# **St. Bernard Port** HARBOR AND TERMINAL DISTRICT

## **Addendum No. 3**

Project Name: Chalmette Slip Dock 2 Section D Warehouse Floor Rehabilitation  
State Project No: H.014603

RECONSTRUCTION OF THE CHALMETTE SLIP DOCK 2 SECTION D

DOCK 2 WHARF D  
DEMOLITION PLAN

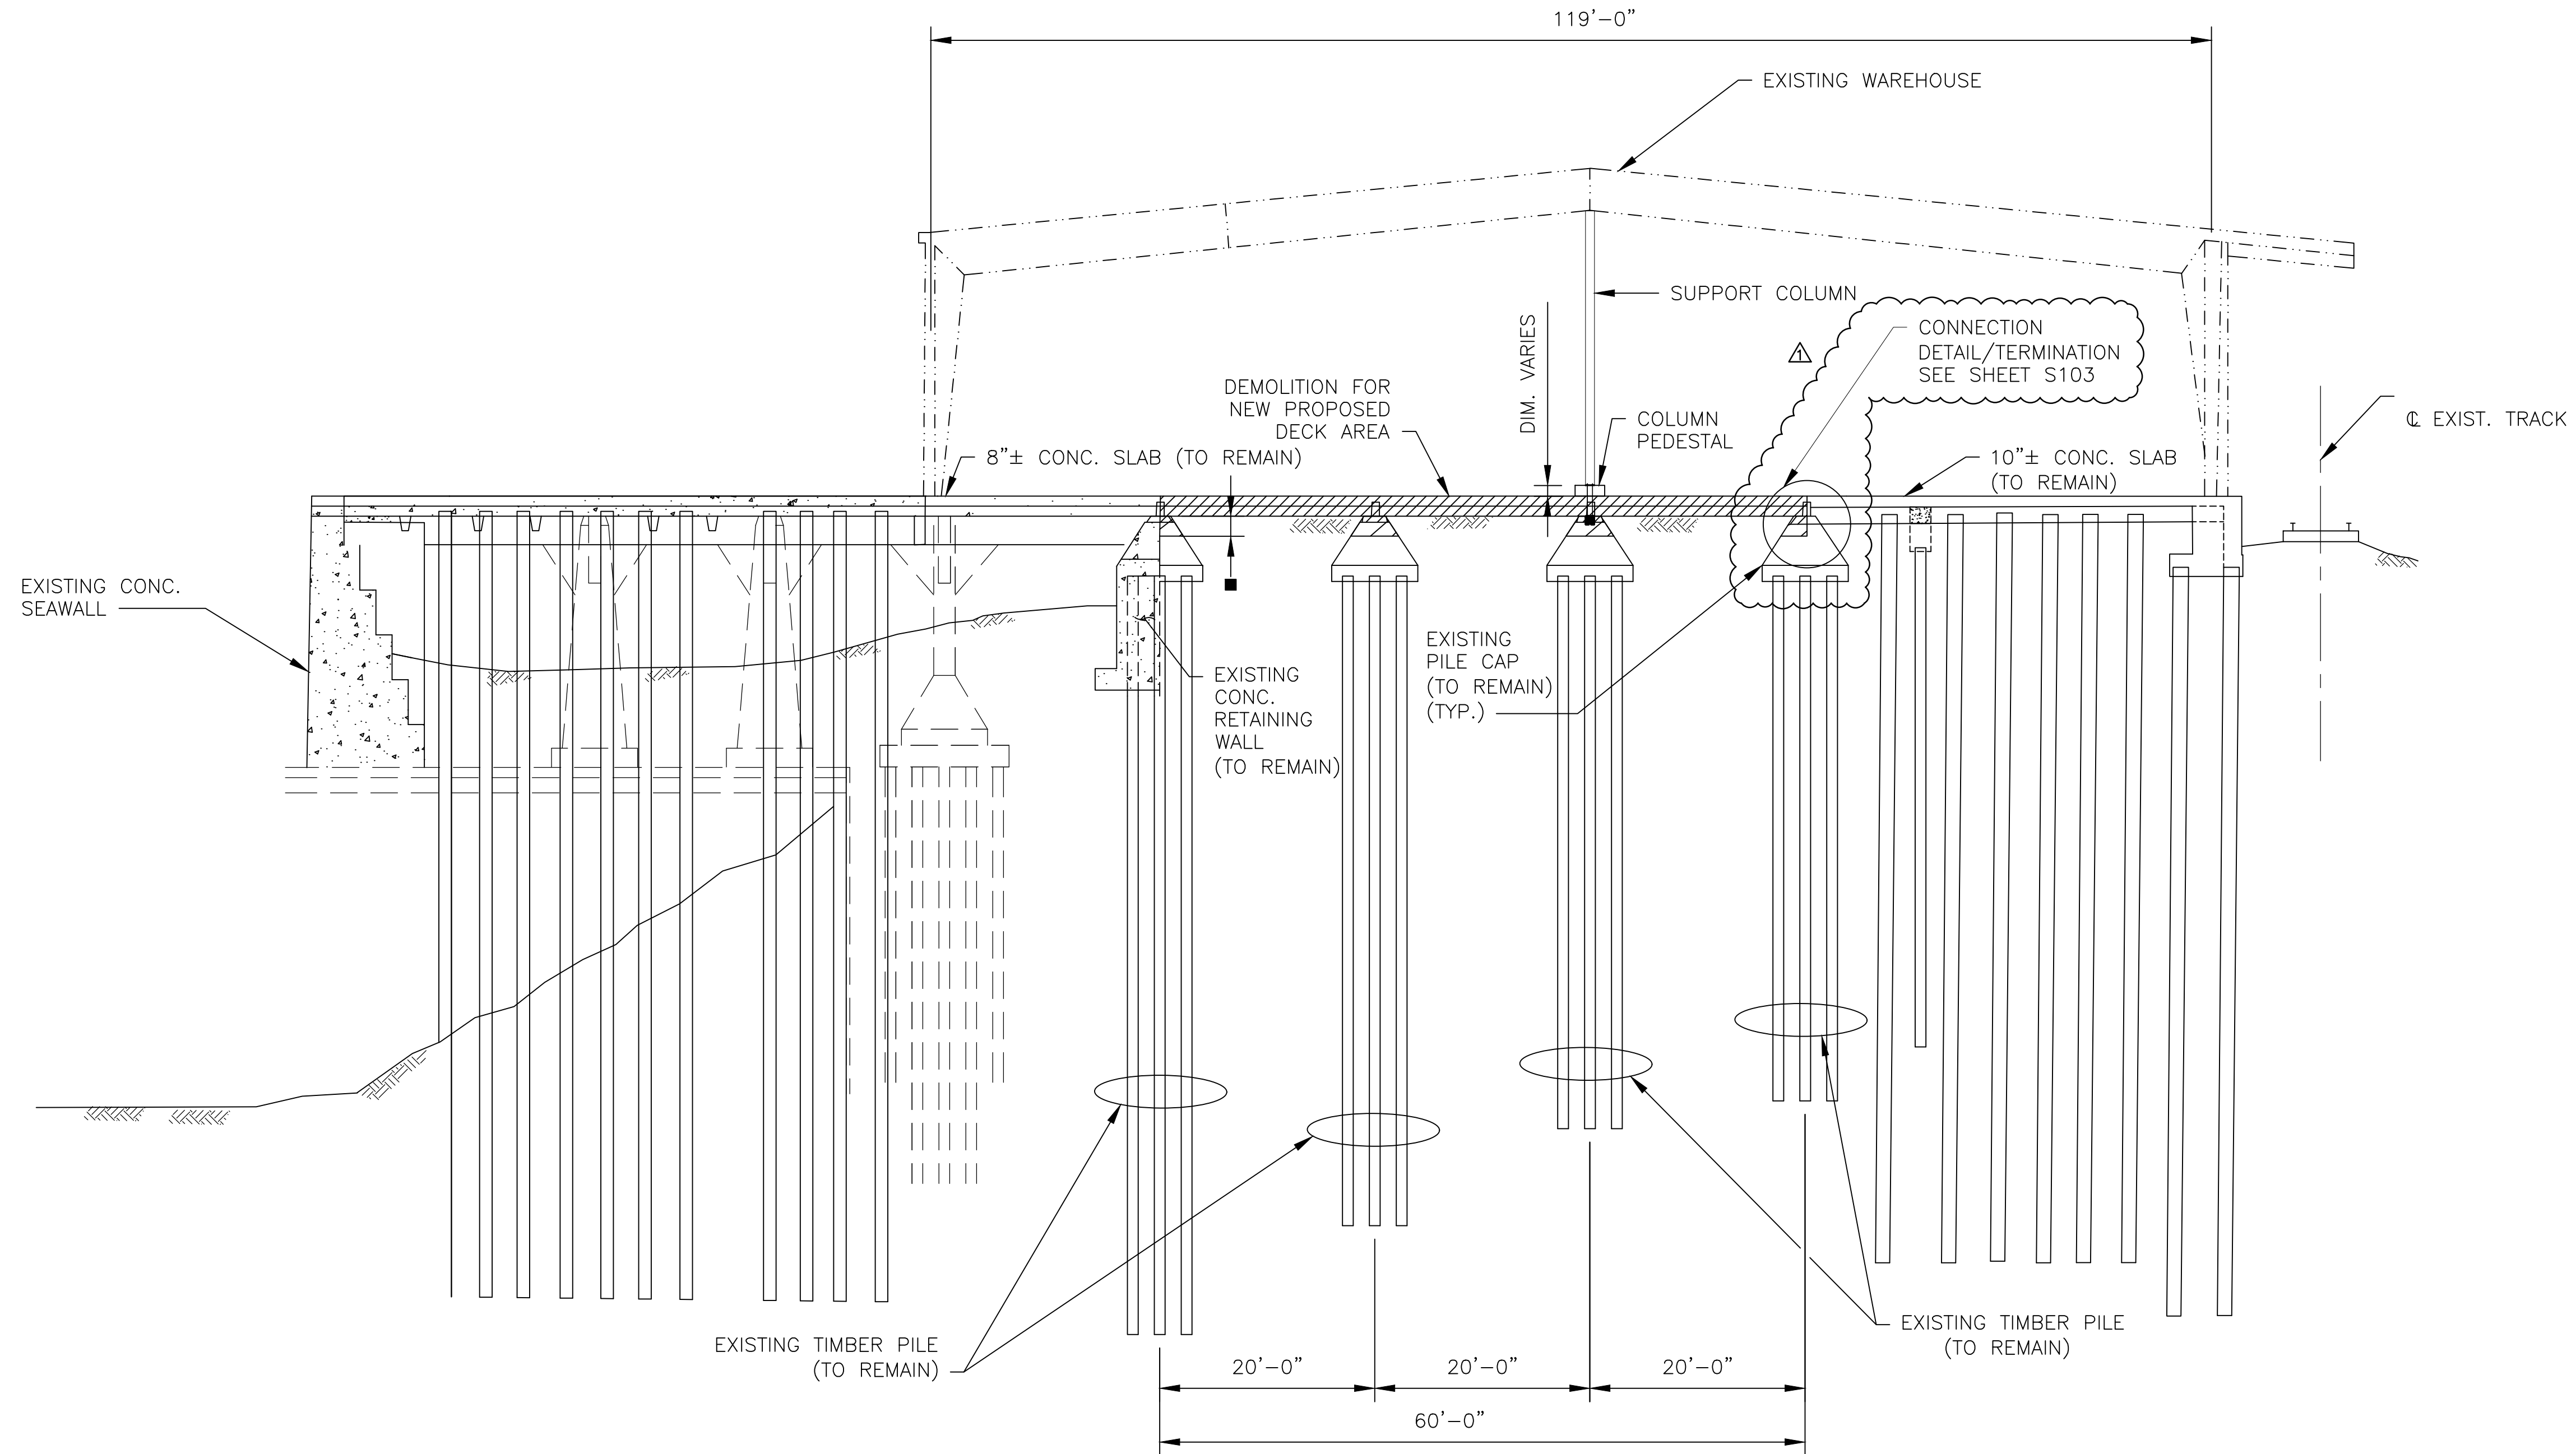
### **A3-4 Plan set Sheet S101 DOCK 2 WHARF D DEMOLITION PLAN update**

Remove existing Sheet S102 and replace it with attached sheet which has been updated to match limits of demolition as shown on Sheet S102a. 1 Page

VIBRATION DURING CONSTRUCTION SHALL BE MINIMIZED. FOR THE REMOVAL OF THE EXISTING SLAB, APPLICATION OF ANY TYPE OF BREAKER MOUNTED TO HEAVY EQUIPMENT SUCH AS AN EXCAVATOR OR BACKHOE OR ANY OTHER VEHICULAR JACKHAMMER IS STRICTLY DISALLOWED. TO MINIMIZE VIBRATION, SAWCUT FULL DEPTH SECTIONS OF THE DECK TO ALLOW SECTIONAL LIFTING AND DISPOSAL. SAWCUT OVER THE PYRAMID'S PARAMETERS AND WHEN NECESSARY, USE HAND-HELD JACKHAMMERS NOT TO EXCEED 60 POUNDS TO AID WITH THE REMOVAL OF THE DECK ON TOP OF THE PYRAMIDS. CONTRACTOR TO DETERMINE THE SIZE OF DECK SECTIONS TO BE SAWCUT FOR REMOVAL AND DISPOSAL BASED ON HIS MEANS AND METHODS OF REMOVAL AND DISPOSAL. DEVIATIONS FROM THESE REQUIREMENTS MUST BE APPROVED BY THE ENGINEER OF RECORD.

■ PYRAMIDS WILL EITHER NEED TO BE LOWERED OR BUILT UP DEPENDING ON THE MODIFICATION NEEDED TO MATCH THE ELEVATION OF THE BEAM. CONTRACTOR TO VERIFY. (TYP.)
